ADDENDUM NO. 3

Replace Roof, Hospital Building
Confederate Memorial State Historic Site
Higginsville, Missouri PROJECT NO.: X2405-01

Bid Opening Date: 1:30 PM, Thursday, November 18, 2025

5 ENLARGED ROOF PLAN AT LOWER ROOF- ALTERNATE NO. 1
A104/ 1/4" = 1'-0"

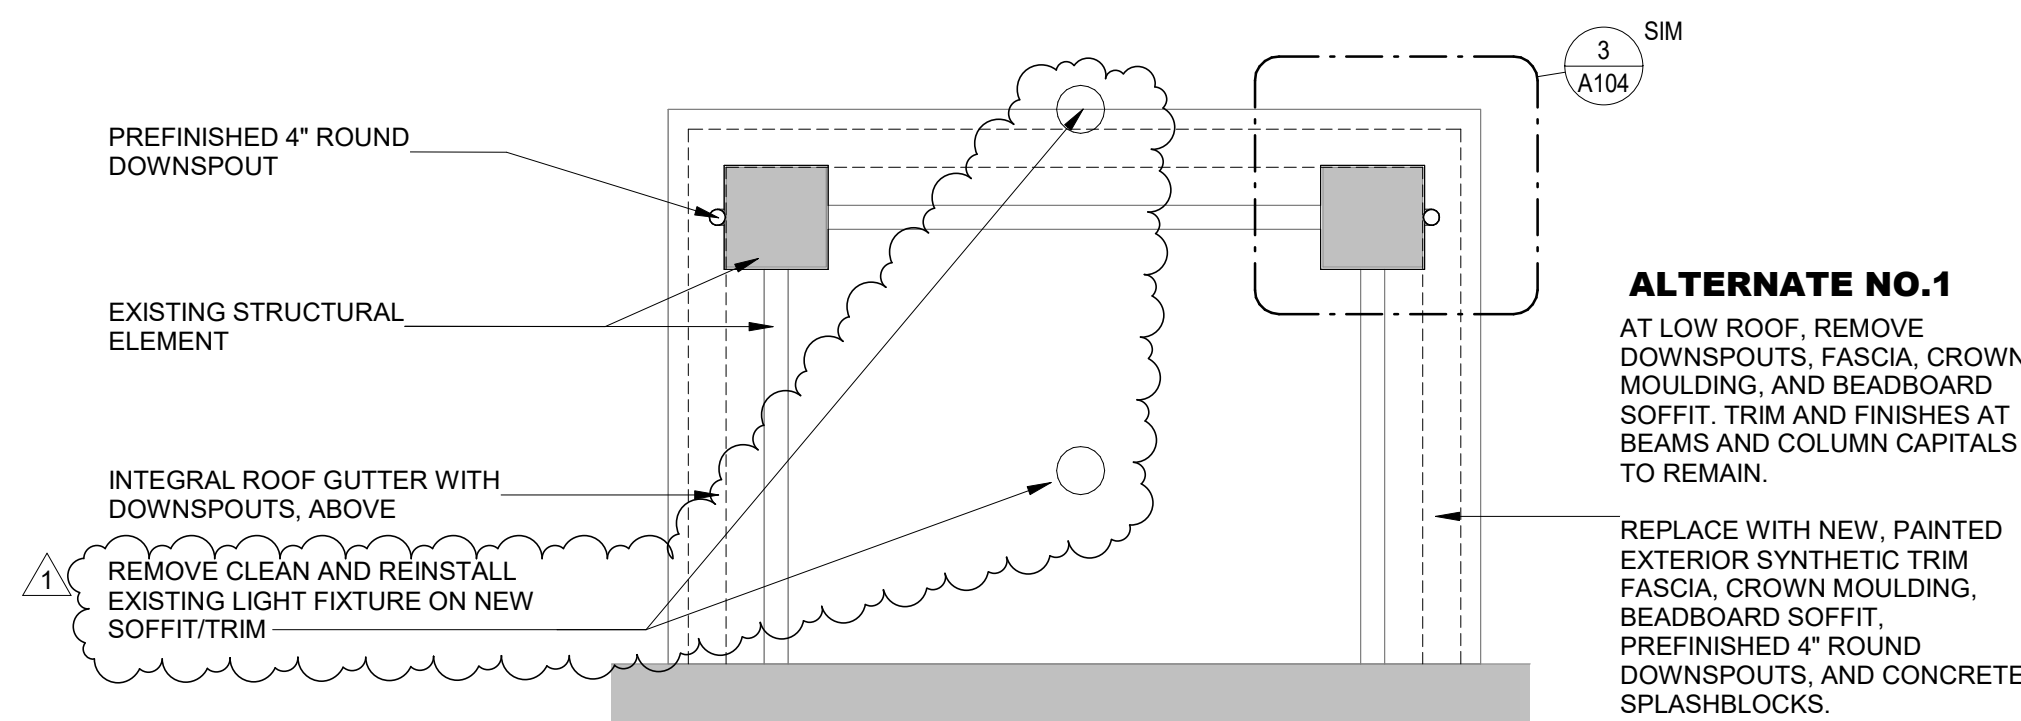
- a. REVISE plan detail 4/A104 to indicate reinstallation of existing light fixtures.
- b. REVISE plan detail 5/A104 to indicate retention of existing integral gutter with roofing replacement.
- c. REVISE plan detail 2/A104 to indicate adjustment of chimney wind brace and addition of flashing at roof penetration.
- d. REVISE plan detail 2/A104 to indicate color of new flashing at chimney, PM-2.
- e. REVISE plan detail 1/A104 to indicate color of painted soffit and trim, P-1.
- f. REVISE plan detail 1/A104 to indicate color of prefinished gutter and downspouts, PM-1.
- g. REVISE plan detail 3/A104 to indicate color of painted soffit and trim, P-1.
- h. REVISE plan detail 3/A104 to indicate color of prefinished gutter and downspouts, PM-1.

3 SECTION DETAIL AT SOFFIT
A521/ 1 1/2" = 1'-0"

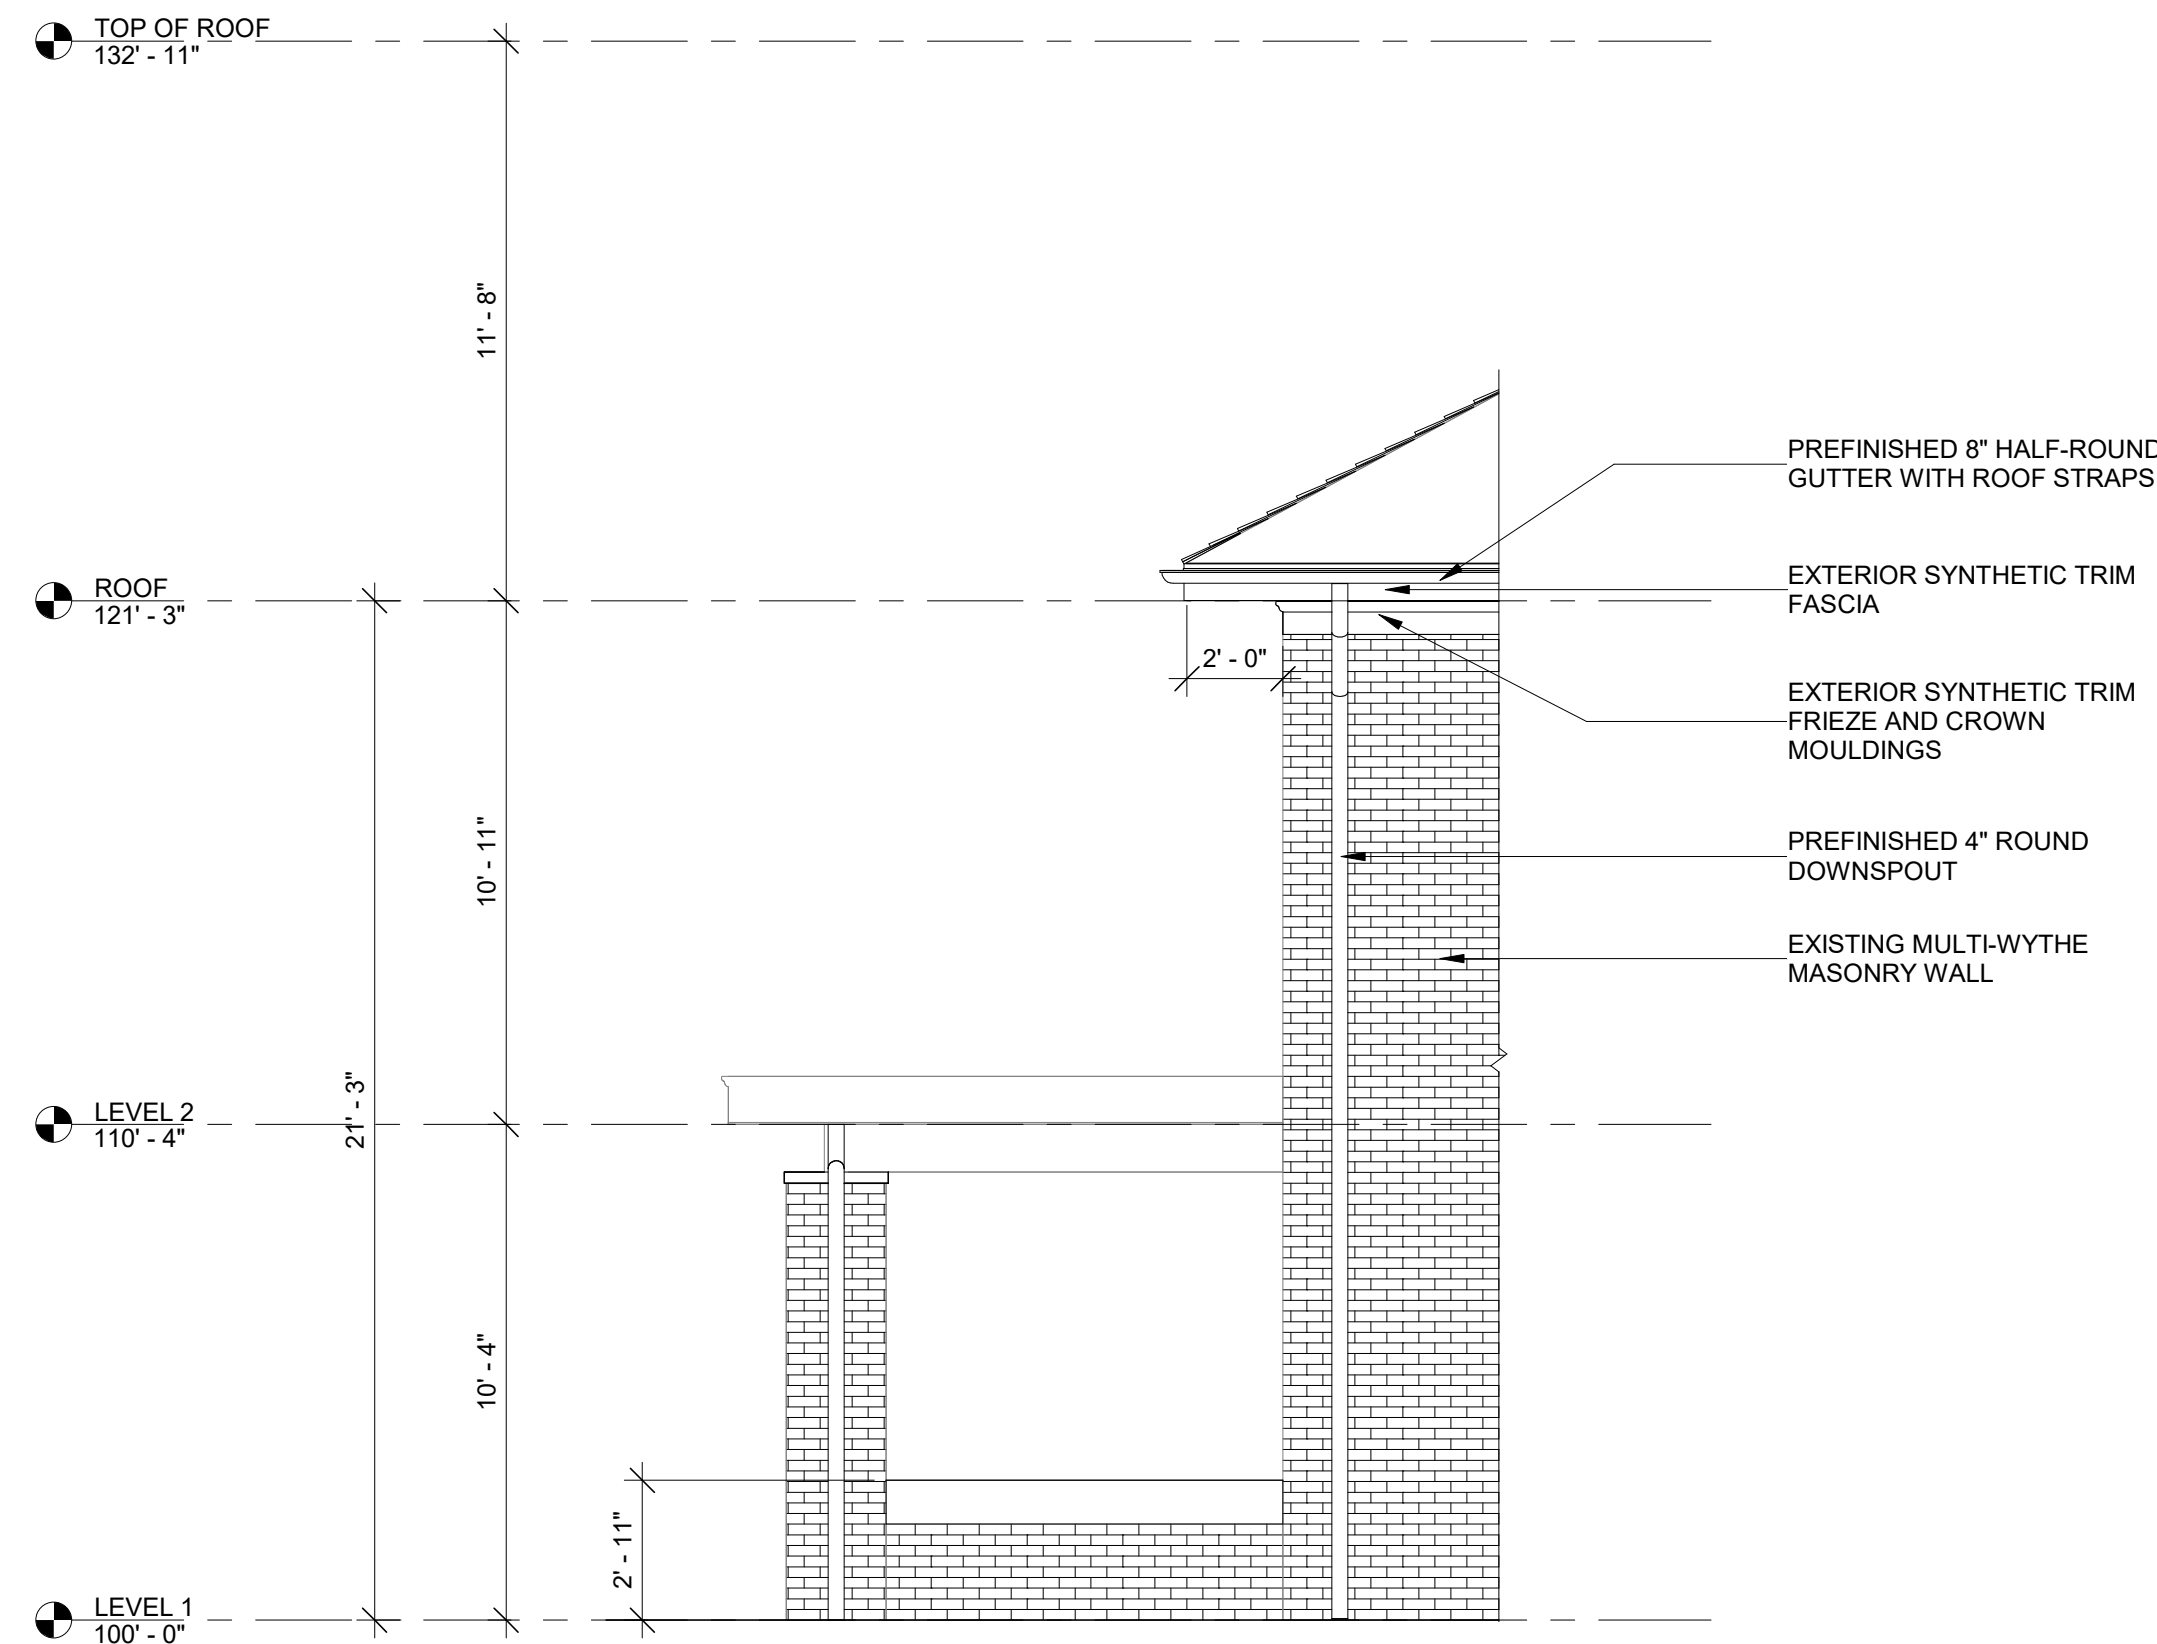
- a. REVISE Detail 3/A521 to add insulation screen between rafters to retain existing insulation.
- b. REVISE Detail 3/A521 to identify material finish colors for pre-finished metal and painted trim.

1 EXTERIOR ELEVATION - SOUTHWEST
A521/ 1/4" = 1'-0"

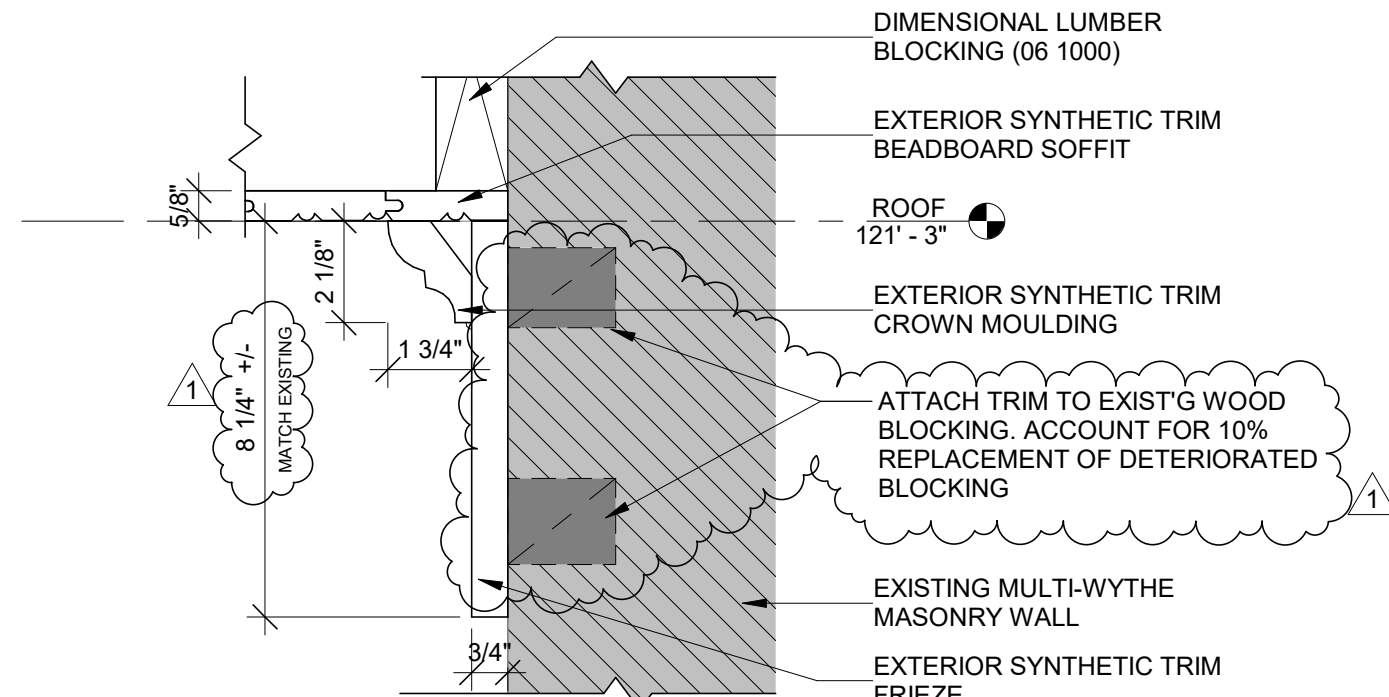
- g. REVISE Detail 2/A521 to identify fasteners for downspout and mortar repair.

REPAIR OF ANCHOR HOLES IN MORTAR JOINTS FOLLOWING DOWNSPOUT REMOVAL SHALL BE MORTAR OF SIMILAR KIND AND CONTENT TO THE EXISTING MORTAR (LOW COMPRESSIVE STRENGTH TYPE "O"). THE MORTAR SHALL BE OF SIMILAR COLOR TO THE ORIGINAL

4 SECTION DETAIL AT FRIEZE TRIM
A521/ 3" = 1'-0"

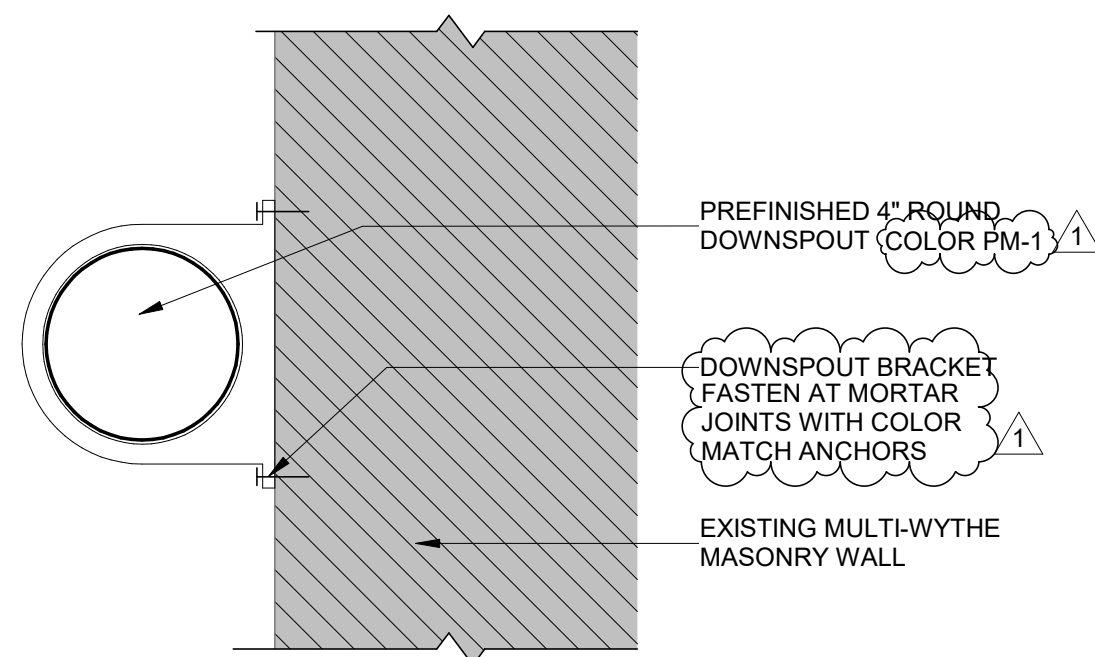
special anchors to attach new trim directly to existing brick in lieu of wood anchors. Reference new Drawing detail 4/A521.

- c. REVISE Detail 4/A521 to show existing wood blocking in masonry behind new trim with new note regarding 10% replacement and new note regarding Allowance for alternative anchors into brick.

NOTE: SEE SPECIFICATION SECTION 012100 ALLOWANCES FOR ALTERNATIVE FASTENING DIRECTLY TO BRICK IF REQUIRED
